DATE: 05/28/2026	JOB # 2386
RE: New Units at River Bend	
For Litchfield Housing Authority	
Addendum #3

New Units at River Bend

Addendum #3

05/28/2026

3 TYPICAL EAVE DETAIL
 A1.5 1 1/2" = 1'-0"

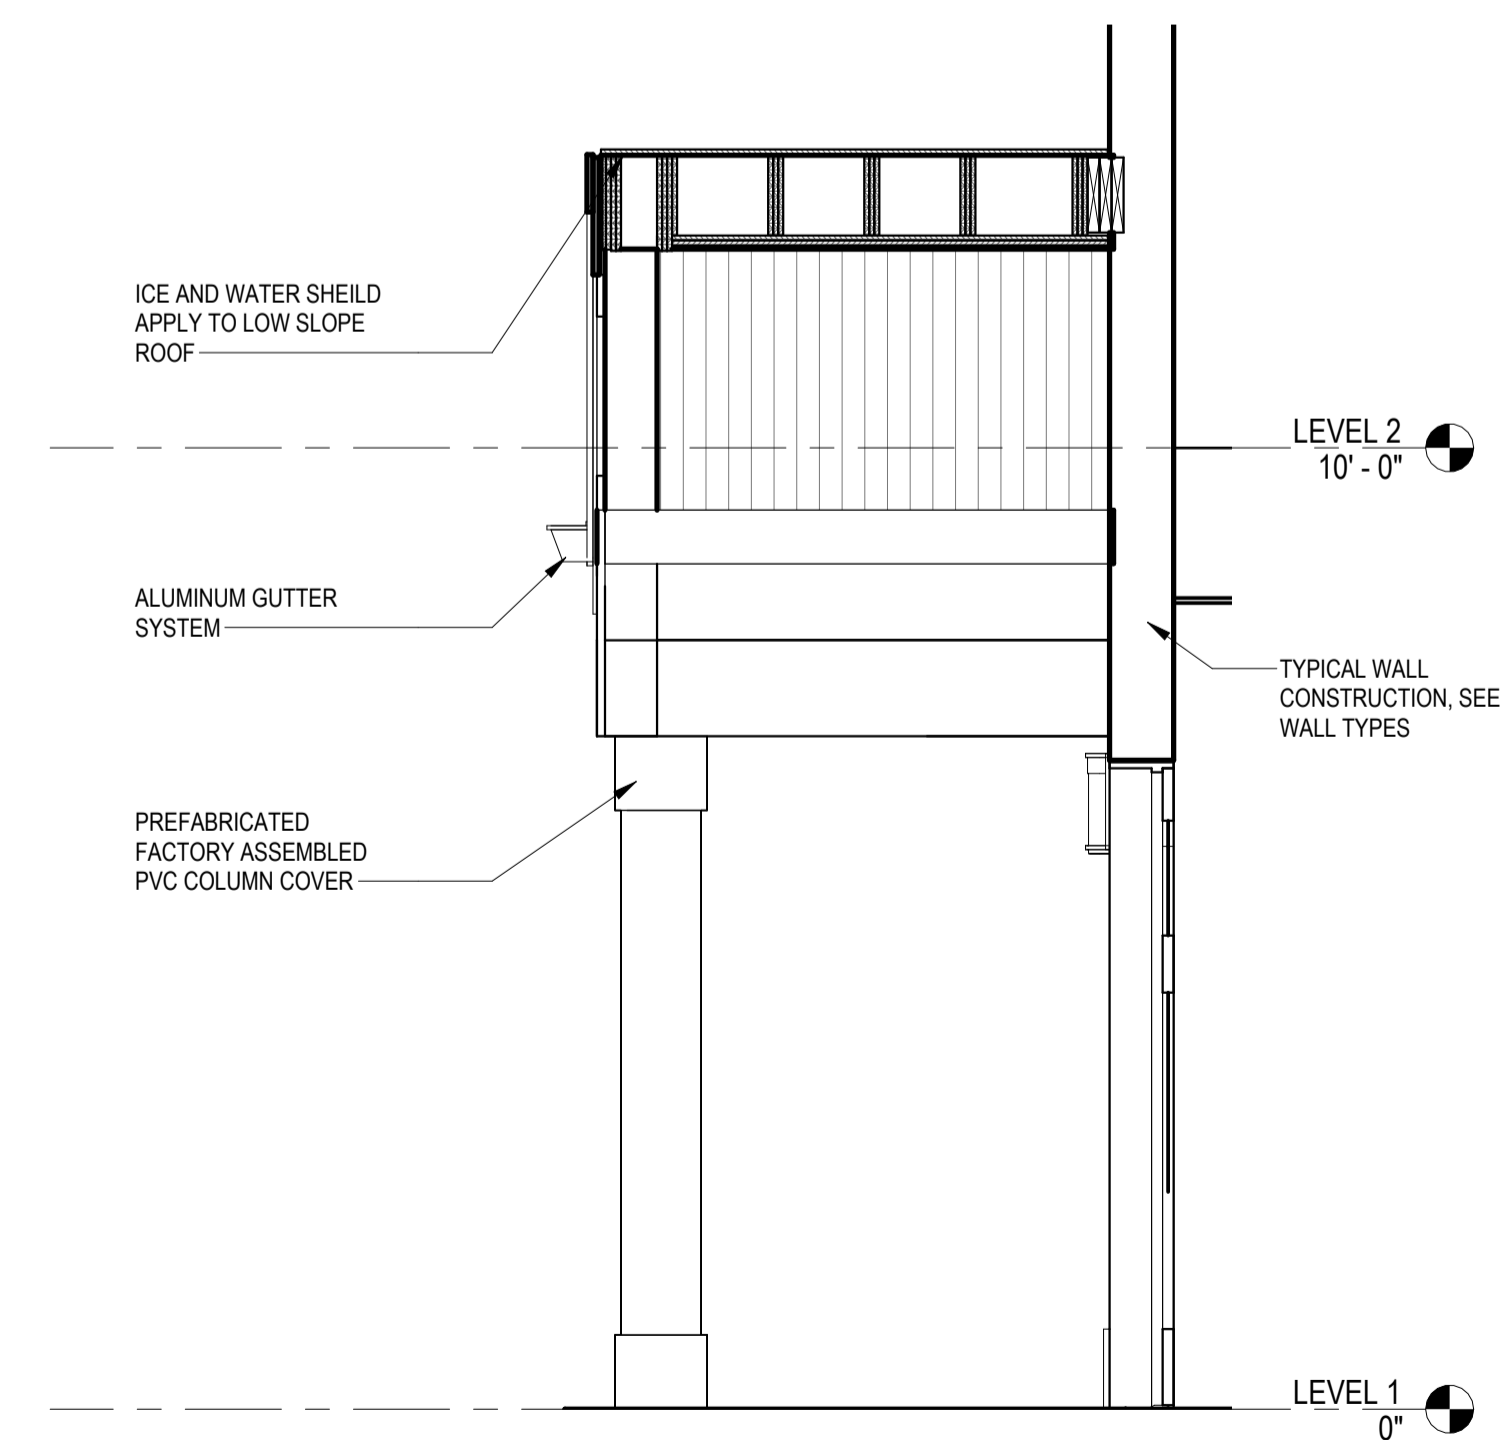
A1.5 **Update** detail 3/A1.5. [attached]

7 WALL SECTION 2 - RAKE DETAIL
A5.1 1 1/2" = 1'-0"

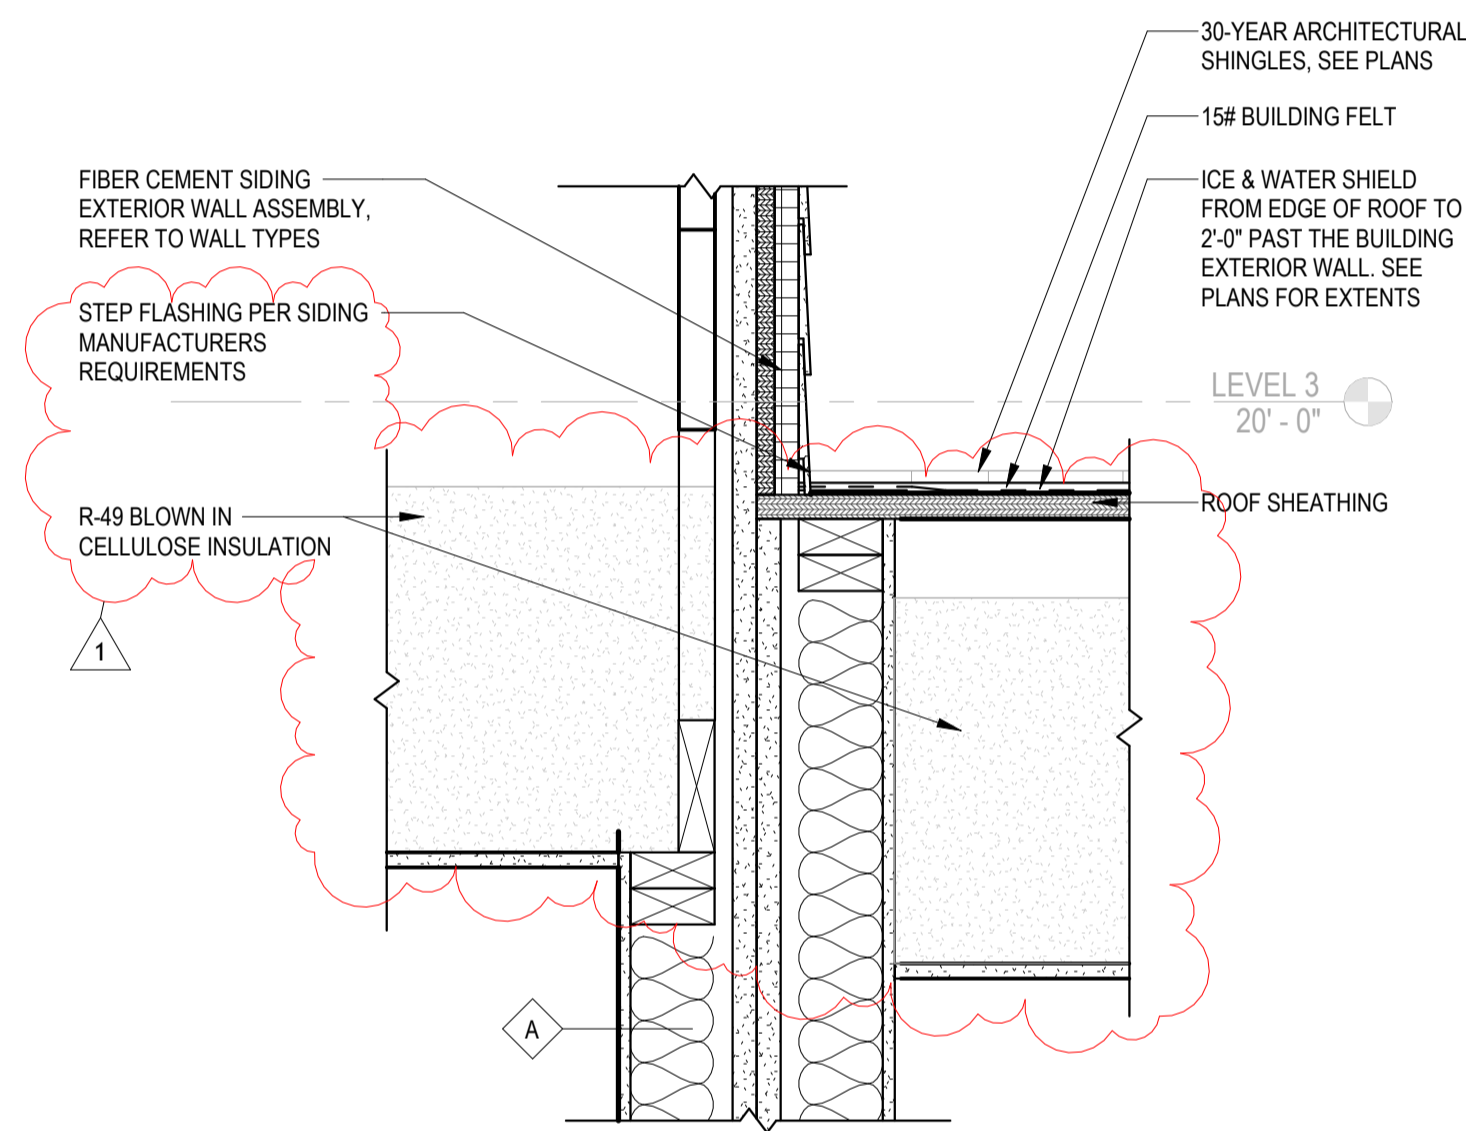
A5.1 **Update** details 3/A5.1, 6/A5.1, 7/A.1 and add note. [attached]

5 WALL SECTION 3 - RAKE DETAIL
A5.2 1" = 1'-0"

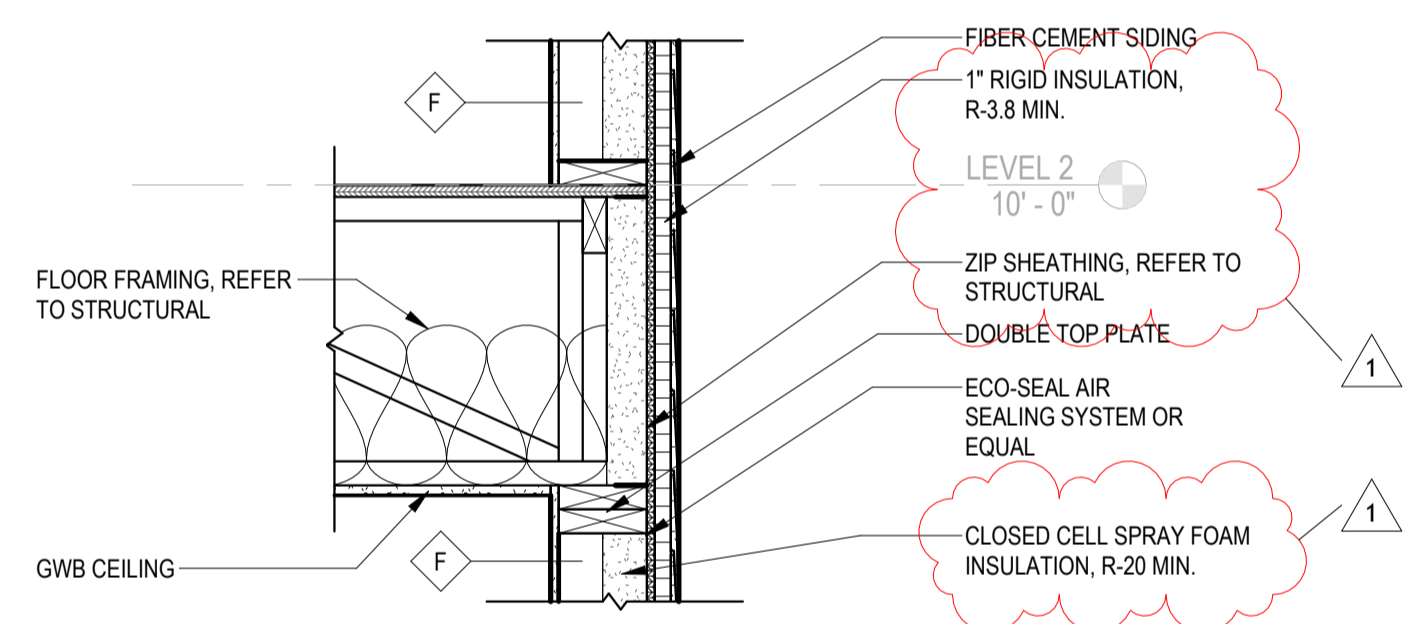
A5.2 **Update** details 1/A5.2, 2/A5.2, 3/A5.2, 4/A5.2 , 5/A5.2 and add note. [attached]

6 WALL SECTION 9 - ROOF DETAIL
A5.4 1 1/2" = 1'-0"

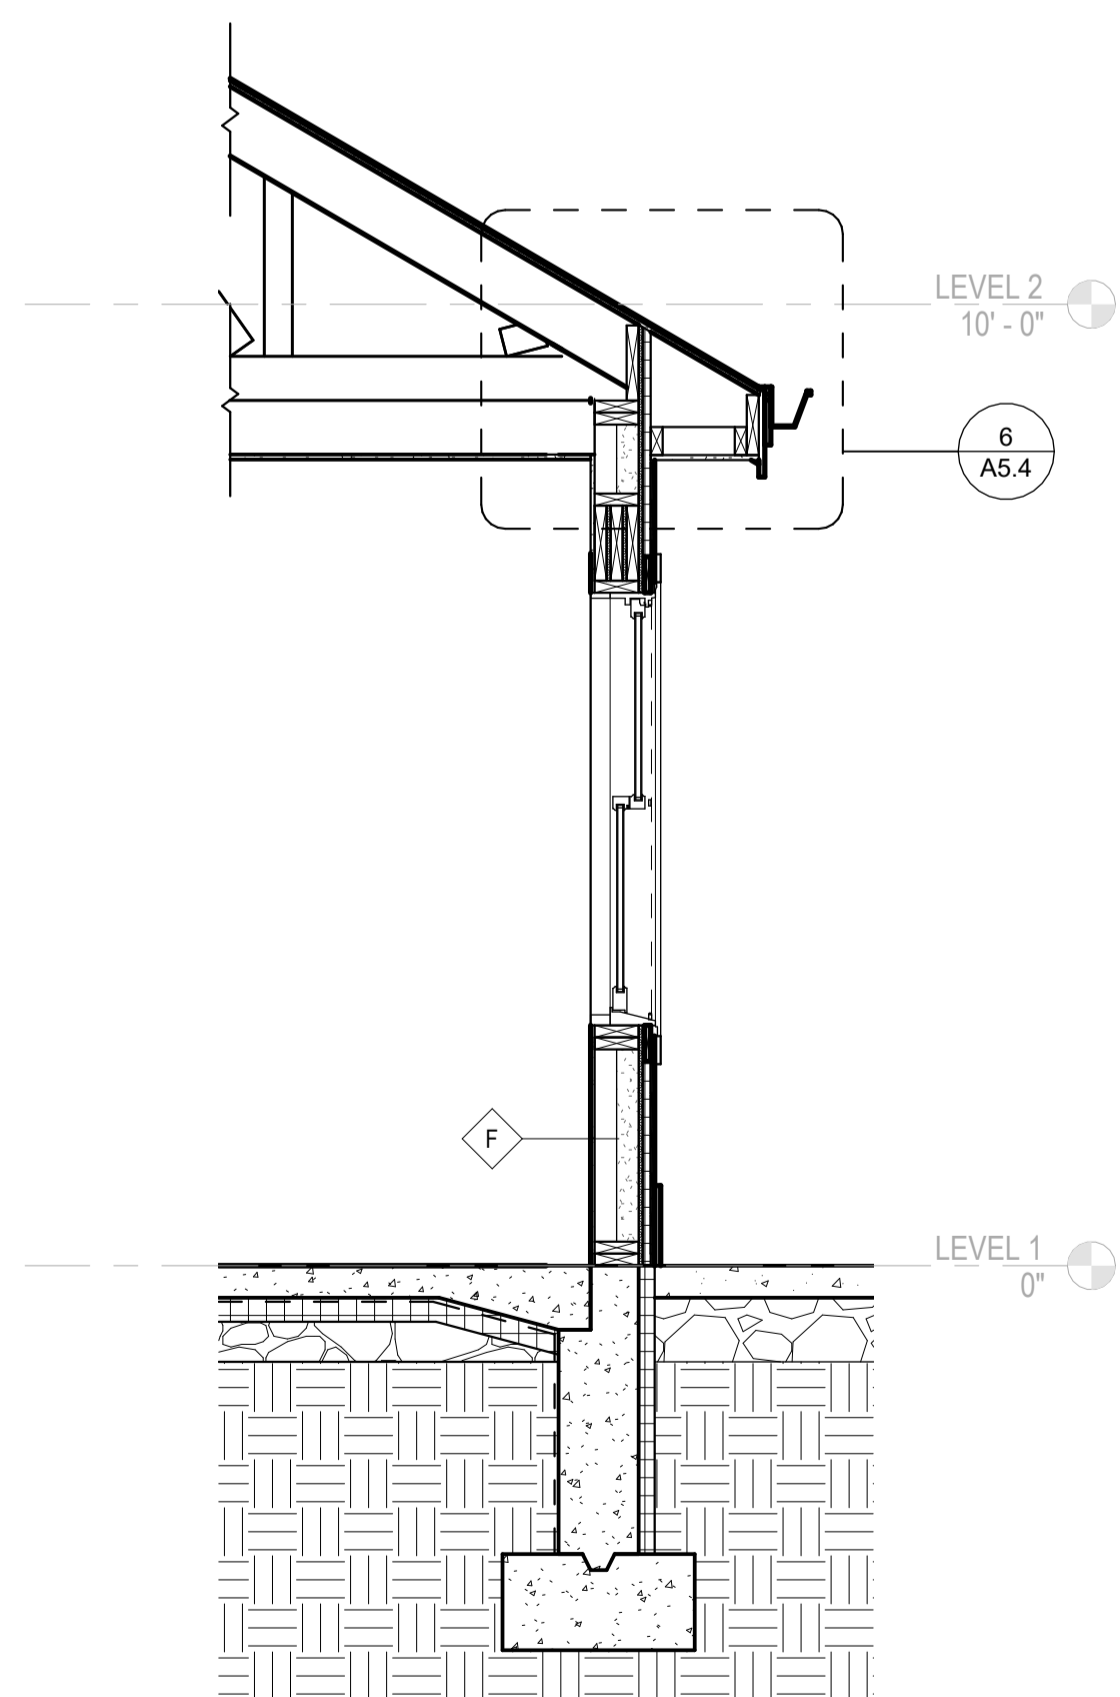
A5.4 **Update** details 2/A5.4, 4/A5.4, 6/A5.4 and add note. [attached]

5 **TYPICAL UNIT D FIRST FLOOR**
P2.1 1/4" = 1'-0"

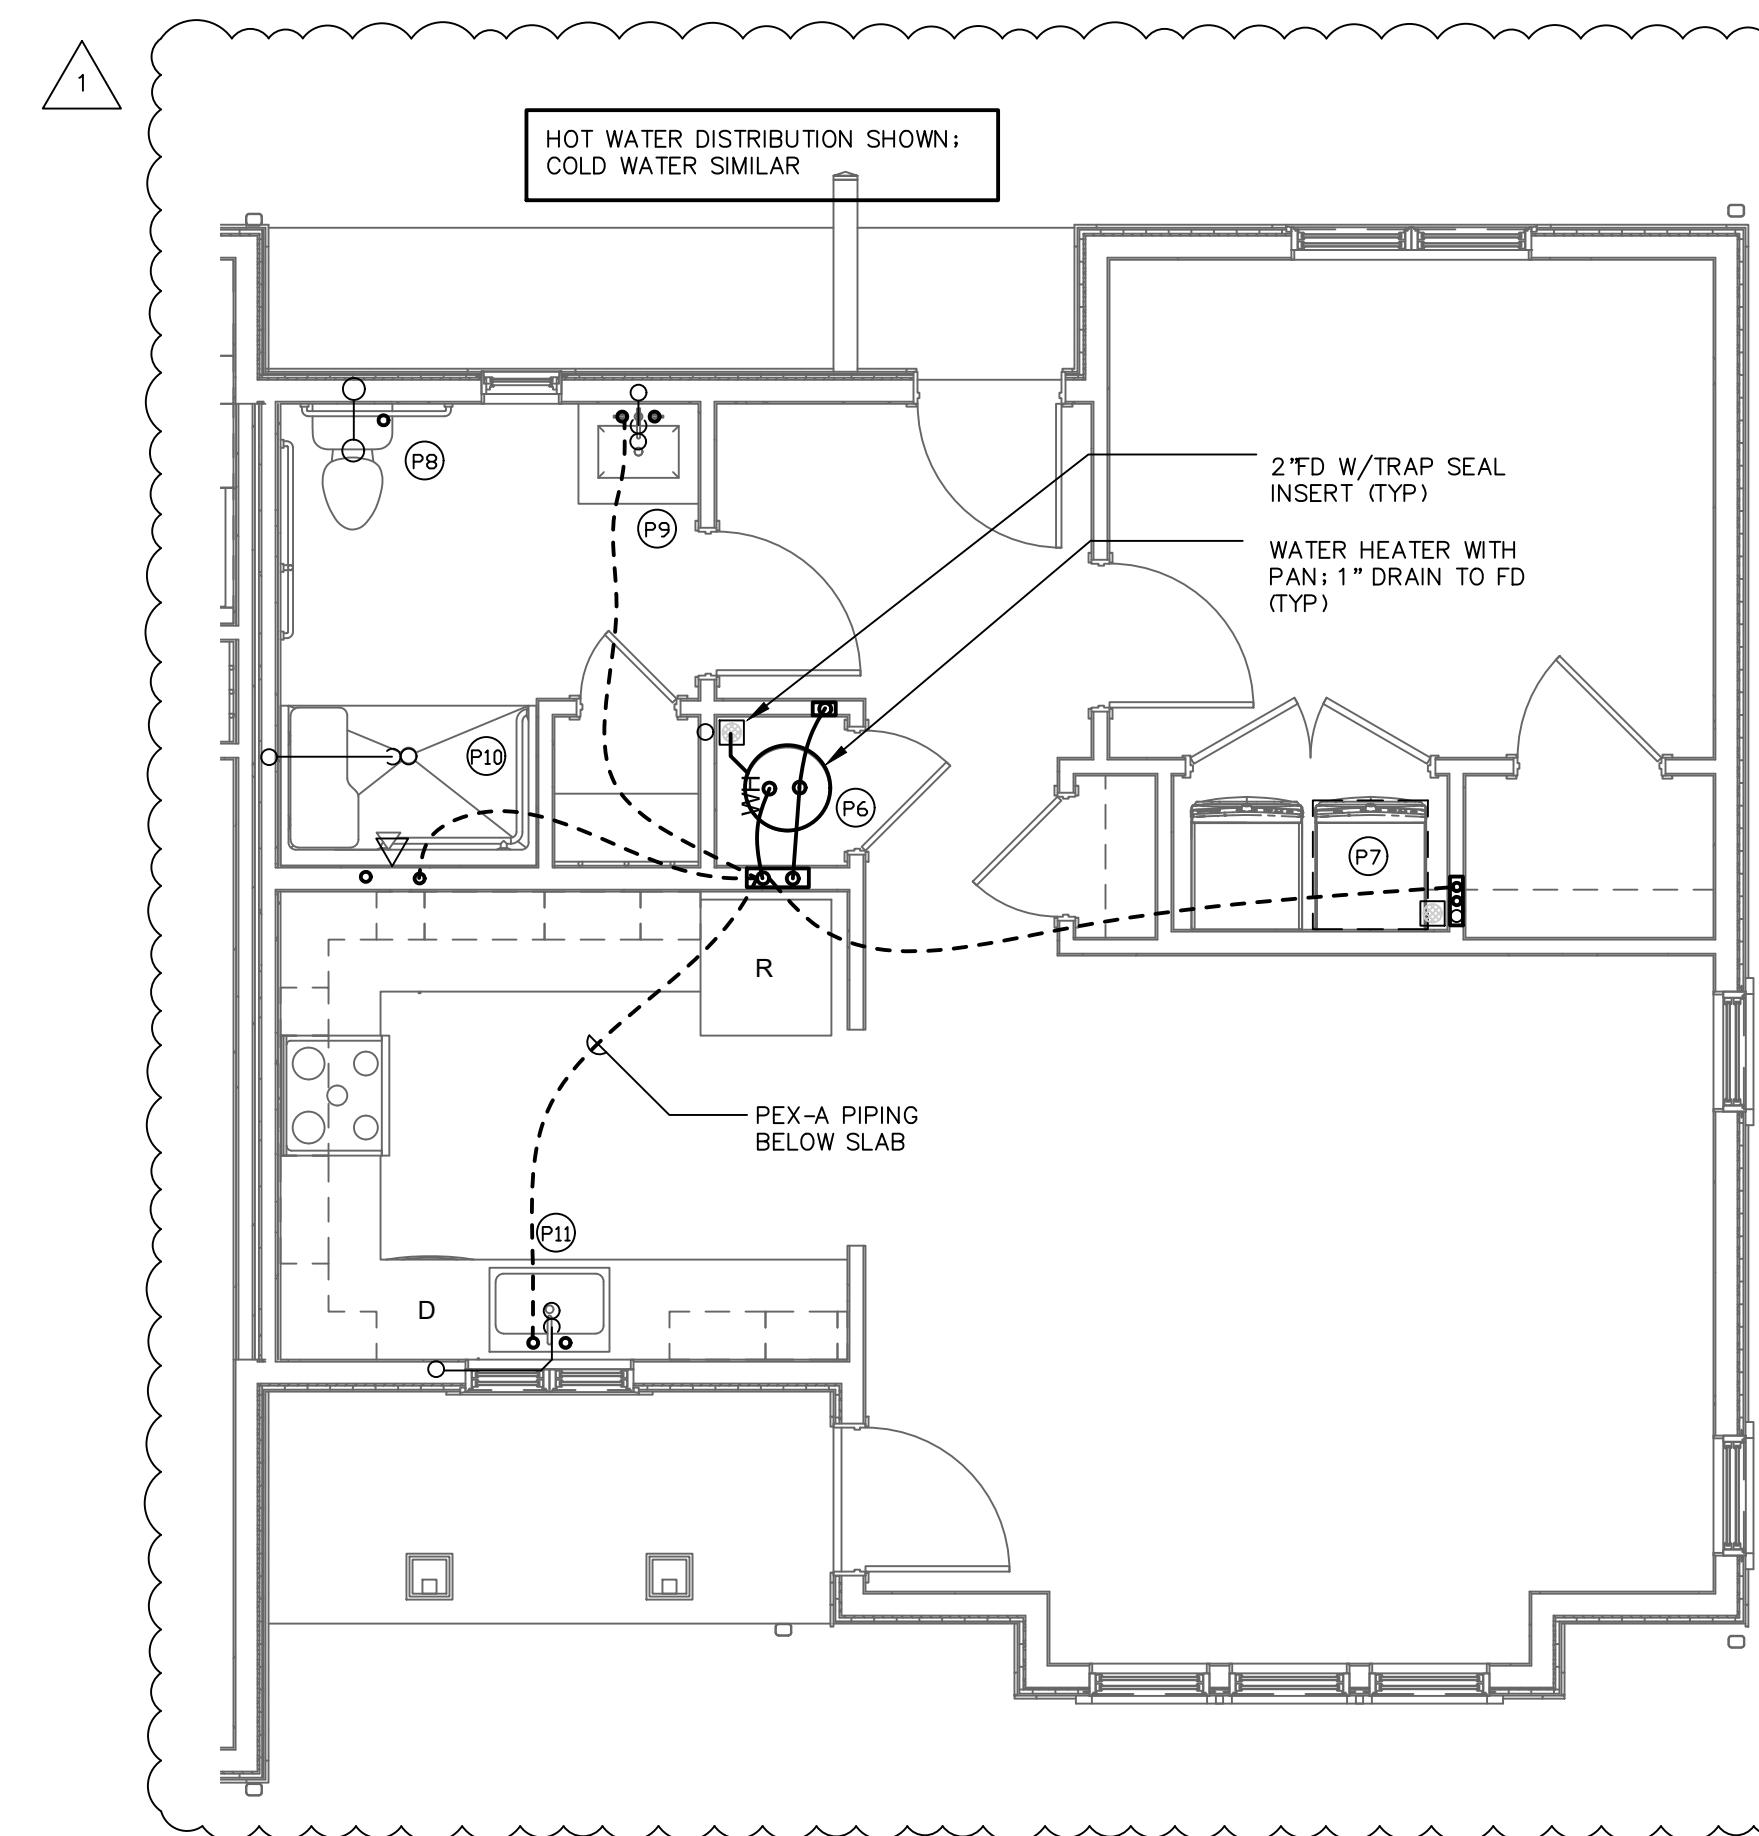
Question #29 Unit D the ADA unit shows a P4 same as everywhere else. This is not a roll in like it is drawing on the arch floor plan. The P4 is spec'd on the fixture schedule as "less ADA trim" is this correct?

- P2.1 **Update** drawing 5/P2.1. [attached]
- P3.0 **Update** Domestic Water service detail. [attached]
- P4.0 **Update** fixture Schedule. [attached]

Answer #29 All ADA units are to have a roll in shower assembly as shown on the architectural drawings. See revised plumbing drawings, attached.
